IN THE DRAWINGS

Applicants have concurrently filed herewith a Letter to the Official Draftsperson submitting formal drawings to replace the originally filed informal drawings, including corrected drawing informalities indicated on Form PTO-948 attached to the Office Action and changes to Figures 2 and 4.

FIG. 2

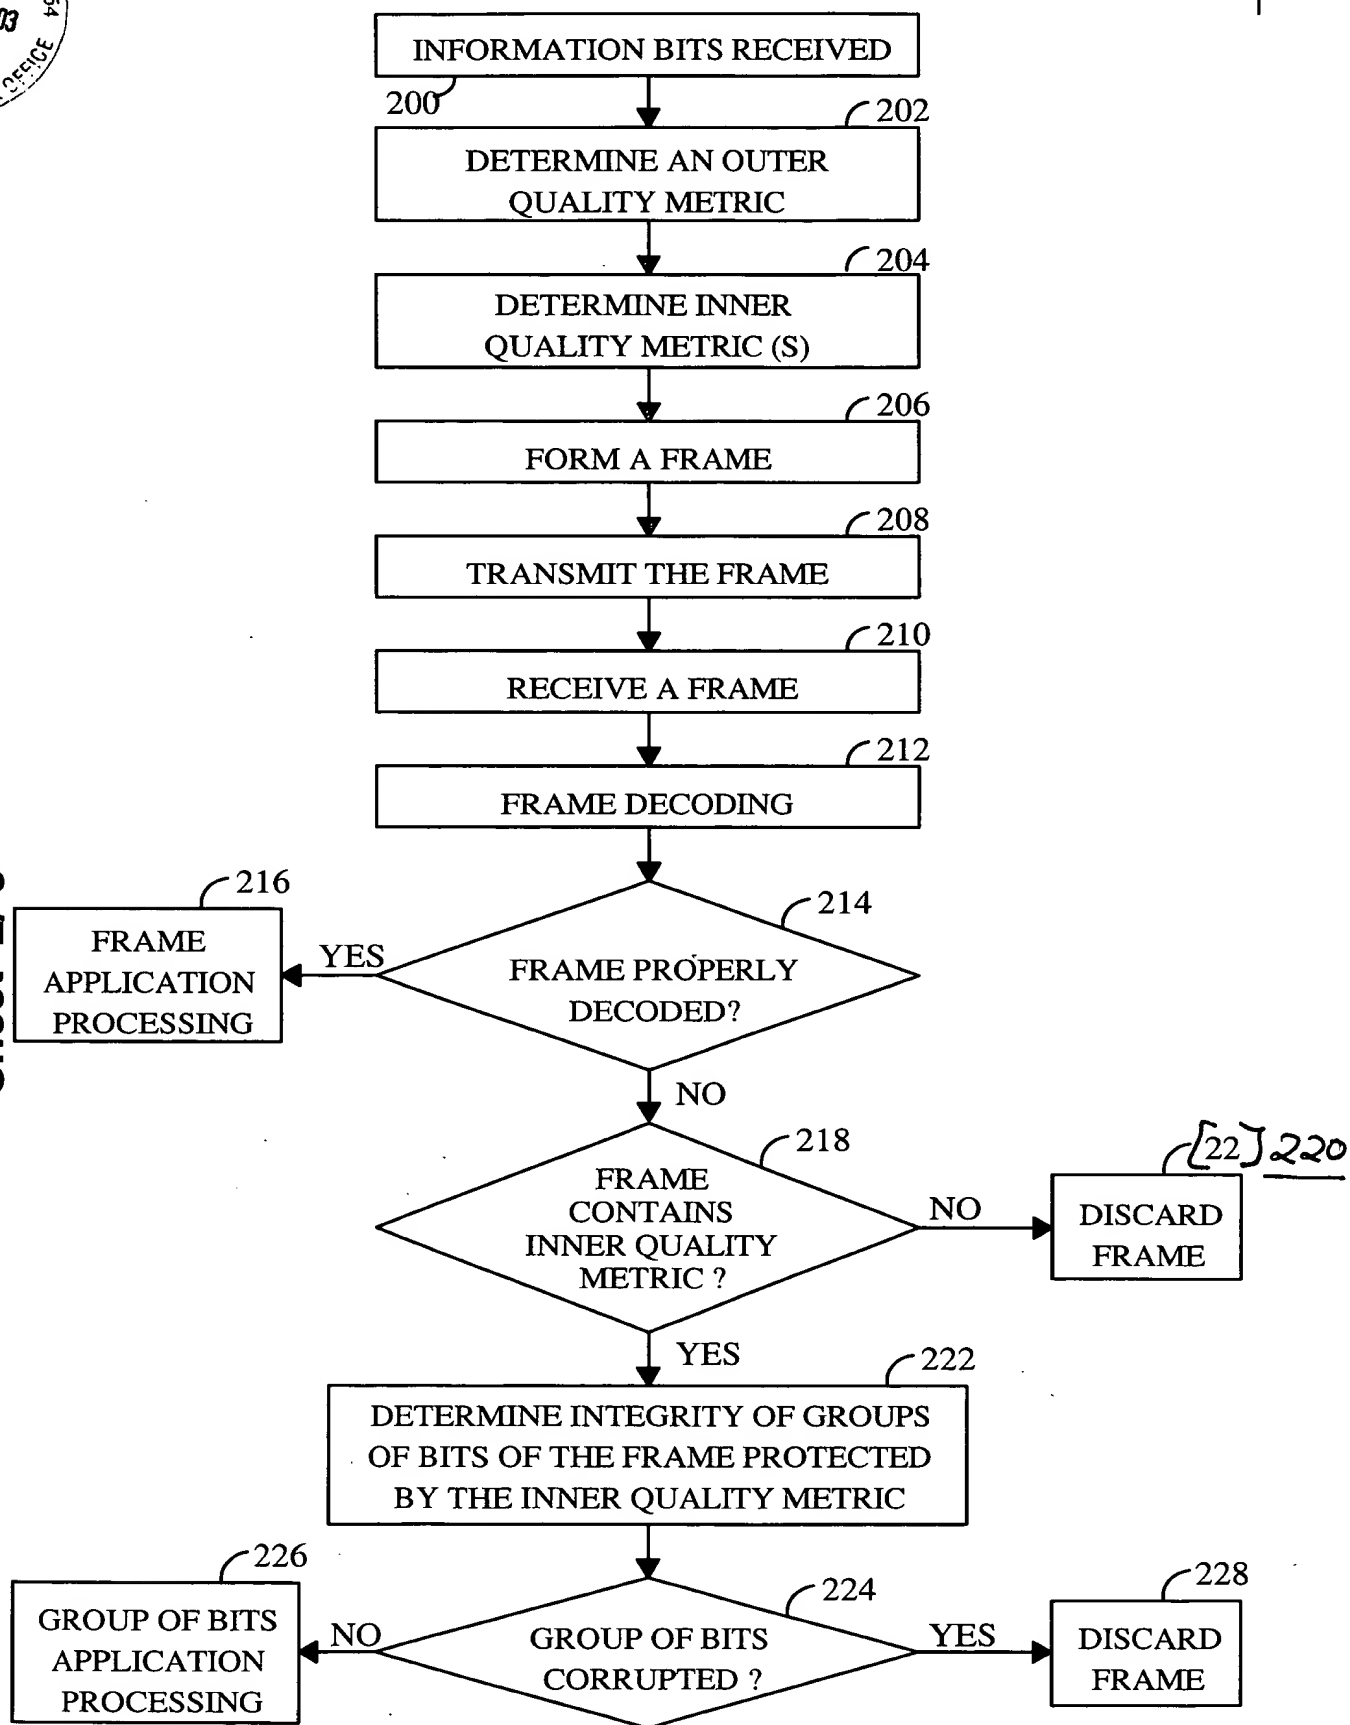
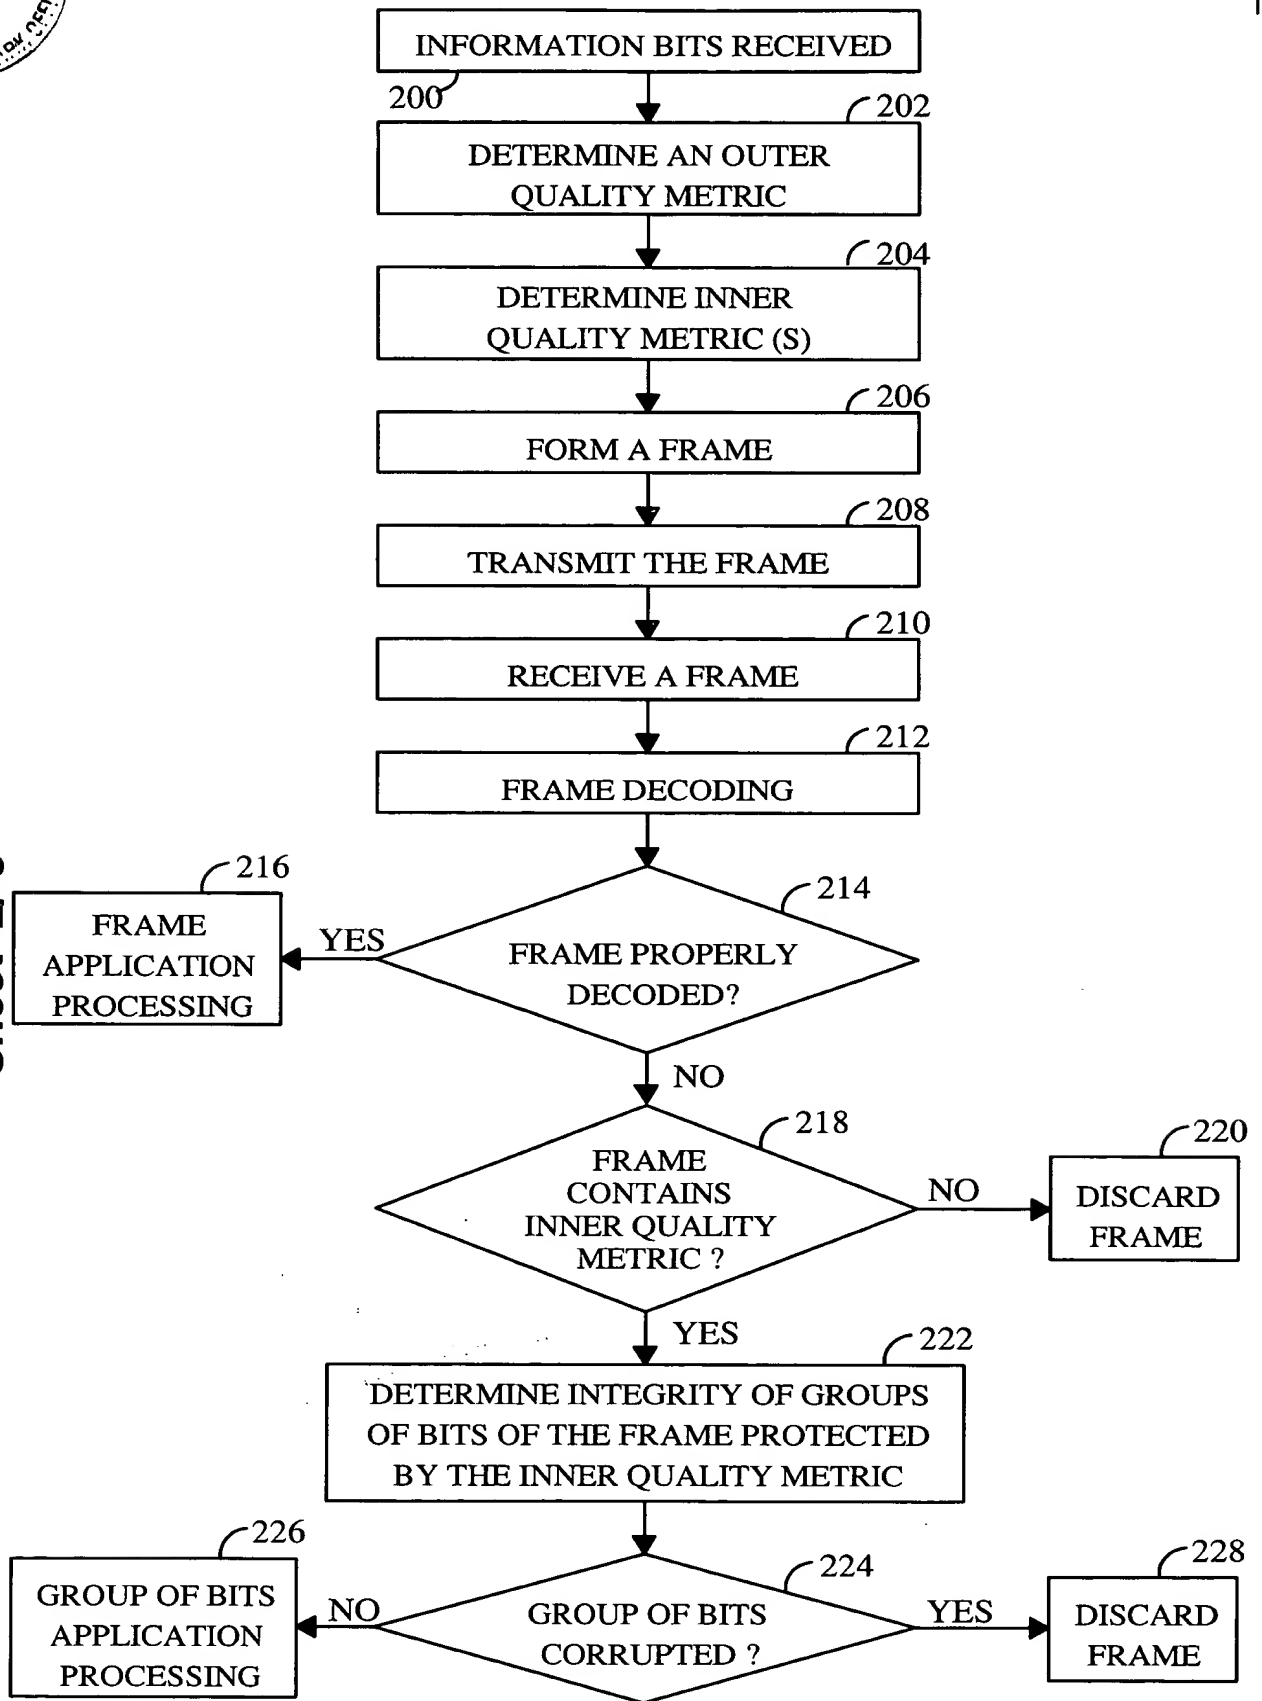
In FIG. 2, please replace reference numeral "22" with - - 220 - -.

FIG. 4

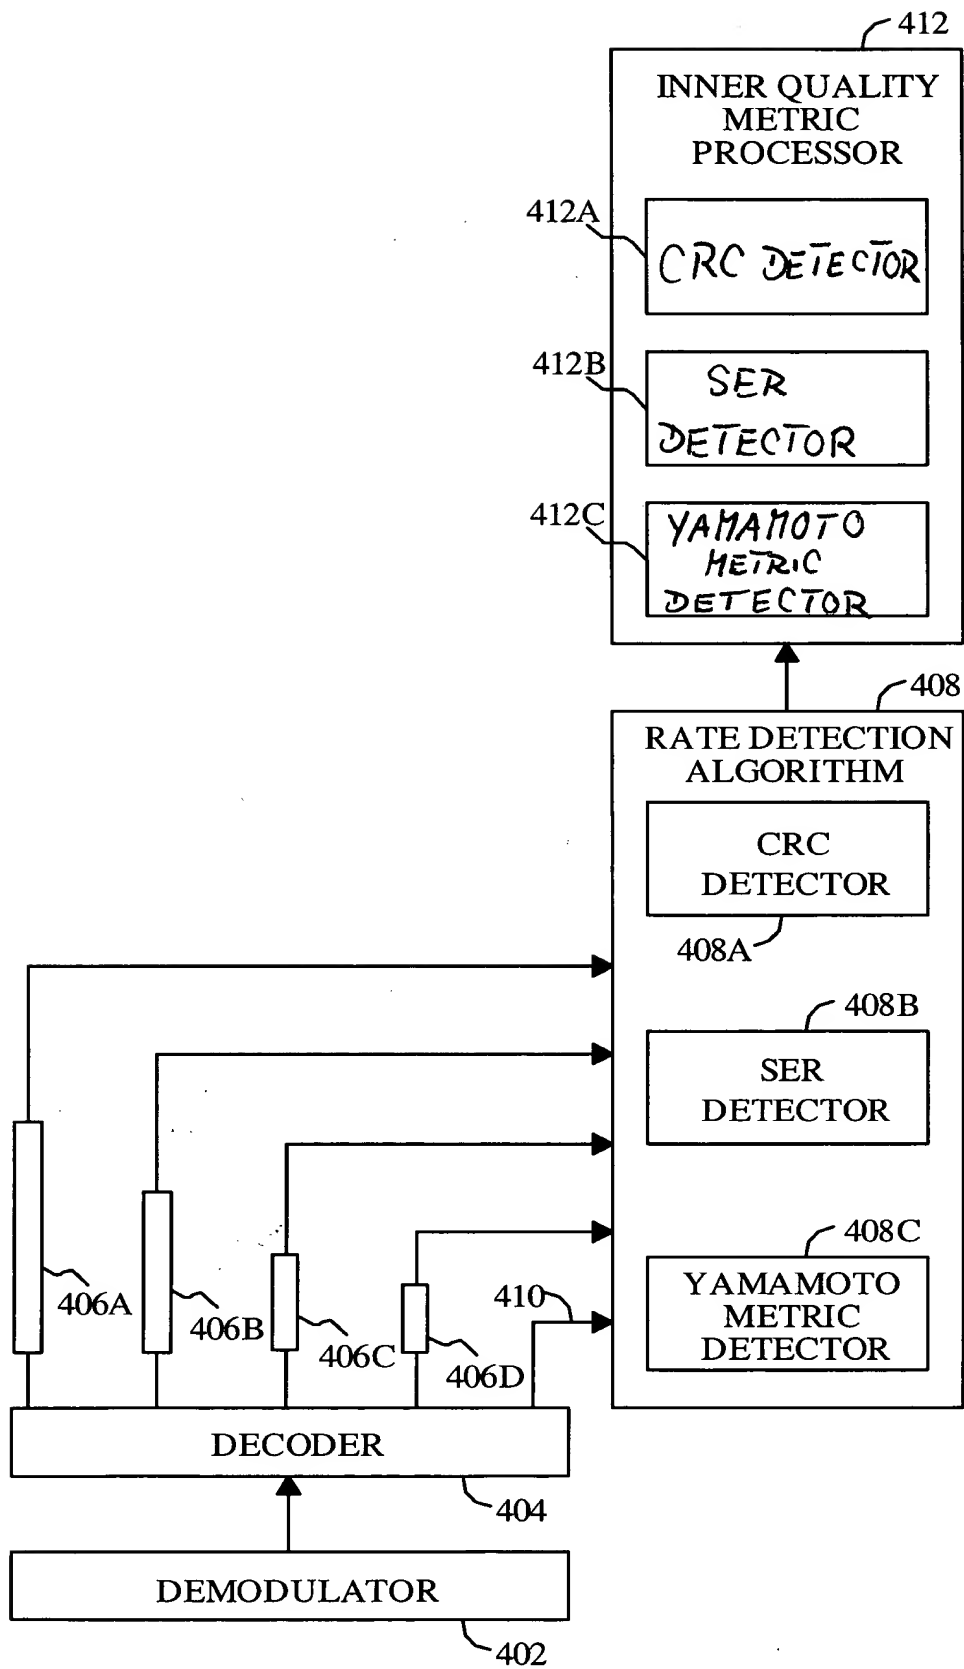
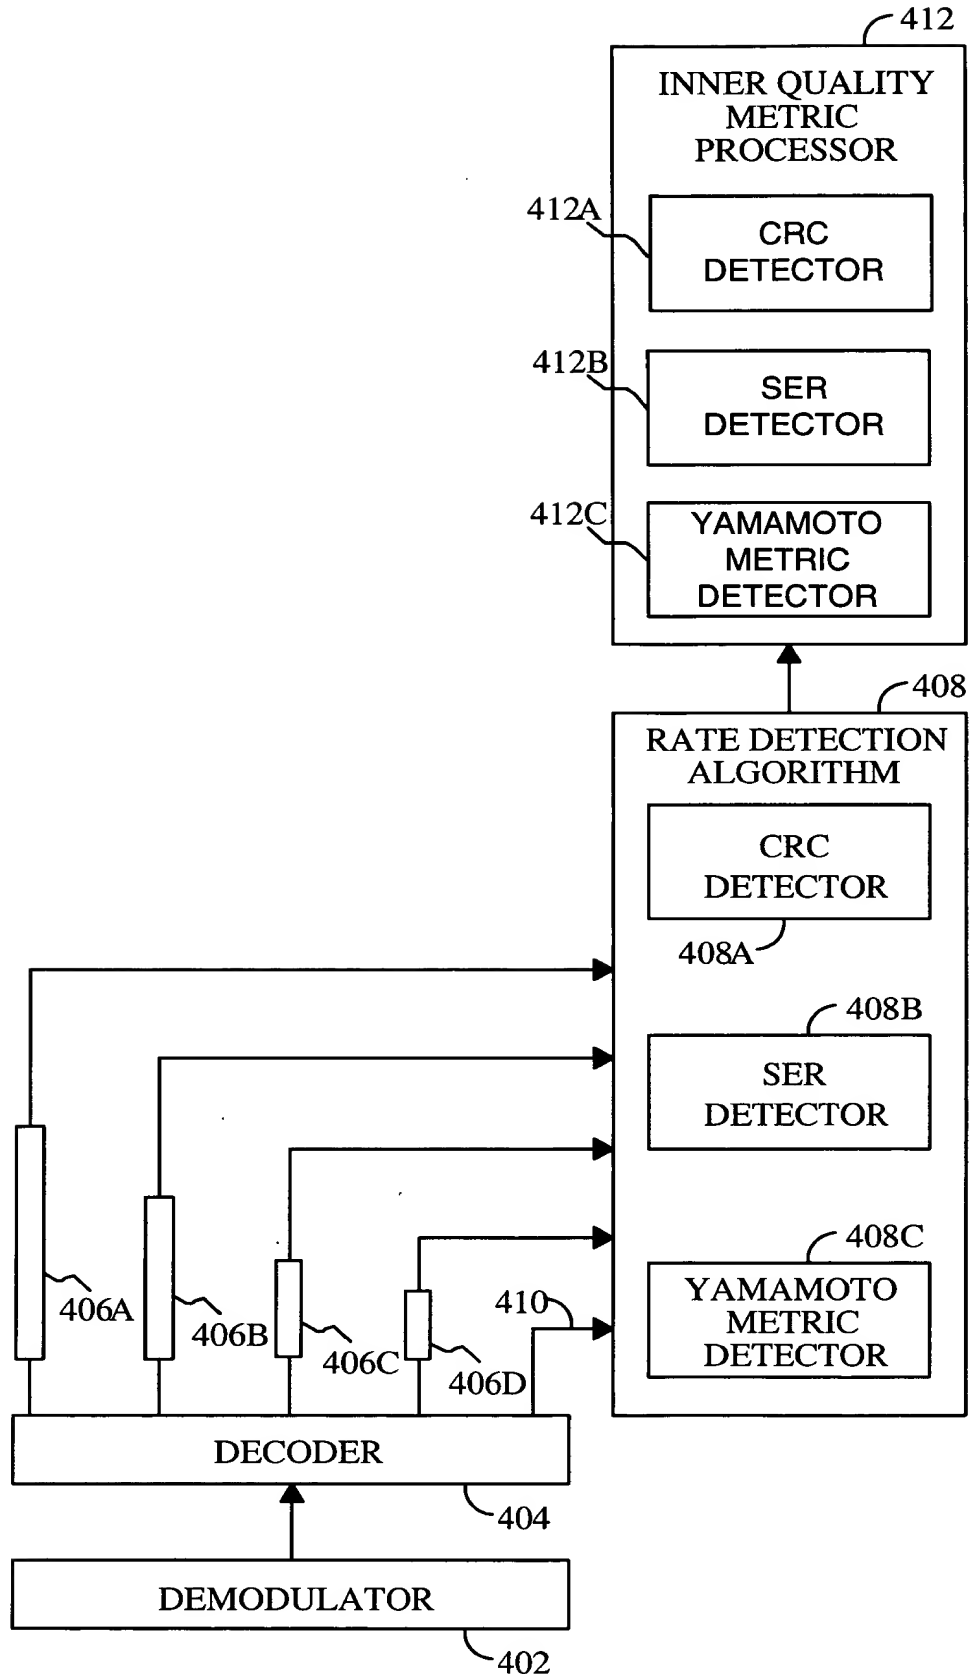
In FIG. 4, please add - - CRC DETECTOR - - to reference numeral 412A.

In FIG. 4, please add - - SER DETECTOR - - to reference numeral 412B.

In FIG. 4, please add - - YAMAMOTO METRIC DETECTOR - - to reference numeral 412C.
